14 CFR Part 36

[Docket No. FAA-1998-4731; Amendment No. 36-22]

Noise Certification Standards for Propeller-Driven Small Airplanes

ACTION: Final rule.

MEASUREMENT WINDOW FOR NO ABSORPTION
Figure G1

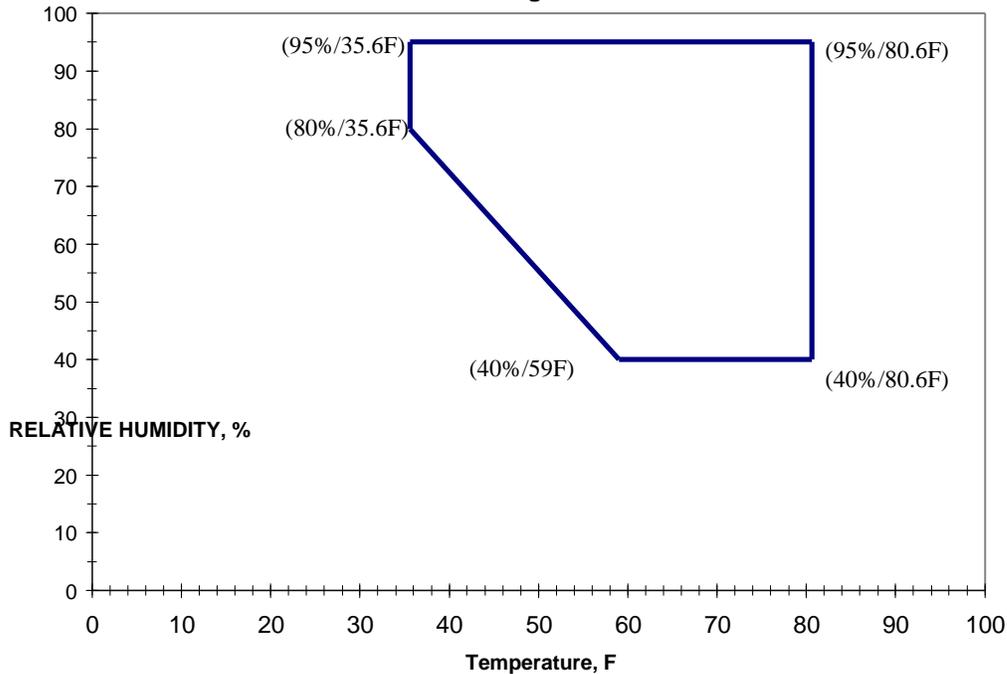
Current § G36.201(b) requires atmospheric absorption correction for noise data obtained when the test conditions are outside those specified in appendix G, figure G1. Noise data collected outside the prescribed range of figure G1 are required to be corrected to 77 degrees Fahrenheit and 70 percent relative humidity by an FAA approved method.

The FAA proposed changing the 77 degrees Fahrenheit reference temperature to 59 degrees Fahrenheit, to be consistent with the ambient temperature requirement in current § G36.111(b)(2), that is used for performance calculations.

Aeromod Services, Inc. objects to changing the 77 degree Fahrenheit reference temperature to 59 degree Fahrenheit in paragraph (b) because it “harmonizes in the wrong direction.” The commenter says that the section should be “placed on the list for JAR 36 harmonization with FAR 36.” Aeromod’s comment goes on to state:

“If we examine the existing FAA and ICAO noise rules, we find that the only rule which does not have a primary or absolute acoustical reference day defined by 77°F/70%RH is Annex 16, Chapter 10. All of the other noise rules, to include FAR 36 Appendix A, Current Appendix G, Appendix H, ICAO Annex 16 Chapter 3, Chapter 4, and Chapter 8, use 77°F/70%RH as the primary or absolute acoustical reference day.”

Aeromod comments that the only section of part 36 which does not have both the performance and acoustic reference day conditions as 77 degree Fahrenheit and 70 percent relative humidity is Appendix G. The reason for this apparent inconsistency is based on the different noise characteristics of other airplane classes, namely large transports and helicopters. Propeller-driven small airplane noise levels are dominated by

temperature of 77 degree Fahrenheit which is different than standard reference conditions used in most aircraft testing. In the field of aeronautics, the International Standard Atmosphere (ISA) is usually used as the standard ambient conditions, and uses a temperature as 59 degrees Fahrenheit. All the performance information in the flight manuals (carried aboard each airplane) are given for ISA conditions. The proposed changes to Appendix G simplifies the data reduction by uniting the performance and acoustic reference conditions for propeller-driven small airplanes at 59 degrees Fahrenheit and 70 percent relative humidity. This section was adopted as proposed.

(b) Atmospheric absorption correction is required for noise data obtained when the test conditions are outside those specified in Figure G1. Noise data outside the applicable range must be corrected to 59 F and 70 percent relative humidity by an FAA approved method.

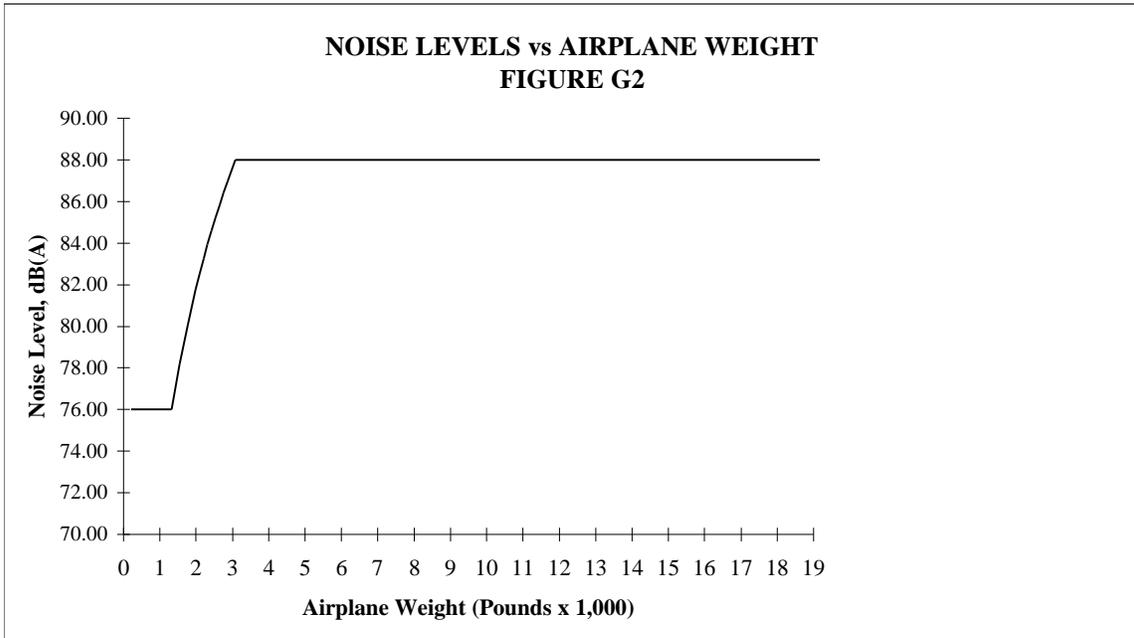
Current § G36.301(b) states that for aircraft weights up to 1,320 pounds (600 kg) the noise level must not exceed 73 dB(A); for weights greater than 1,320 pounds, the noise limit increases at the rate of 1 dB /165 pounds up to 85 dB(A) at 3,300 pounds, after which the noise level remains constant at 85 dB(A) up to and including aircraft weight of 19,000 pounds.

As previously discussed, considerations of microphone location, configuration, and resulting noise limits are interrelated. Since the proposed changes to the noise measurement procedures of § G36.107(a) would result in increases in the measured noise levels of about 3 dB(A), the FAA proposed to increase the limits in § 36.301(b) from 73 dB(A) to 76 dB(A) and from 85 dB(A) to 88 dB(A) to account for these different measurement procedures, but without changing the stringency of the current rule.

In addition to the dB(A) increases discussed, the FAA proposed a change to the interpolation requirement of § G36.301(b). For airplane weights greater than 1,320 pounds, the allowable dB(A) would increase “with the logarithm of airplane weight at the rate of 9.83 dB(A) per doubling of weight until the limit of 88 dB(A) is reached ...,” rather than at the rate of 1 dB/165 pounds up to 85 dB(A) at 3,300 pounds, as under the current rule. The new logarithmic interpolation between the low and high takeoff weights was adopted from the Annex 16, Volume I Chapter 10. The working group analyzed the available data obtained by use of a ground microphone, and decided to adopt the logarithmic interpolation that is between low and high takeoff weights.

(b) The noise level must not exceed 76 dB (A) up to and including aircraft weights of 1,320 pounds (600 kg). For aircraft weights greater than 1,320 pounds, the limit increases from that point with the logarithm of airplane weight at the rate of 9.83 dB (A) per doubling of weight, until the limit of 88 dB (A) is reached, after which the limit is constant up to and including 19,000 pounds (8,618 kg). Figure G2 shows noise level limits vs airplane weight.
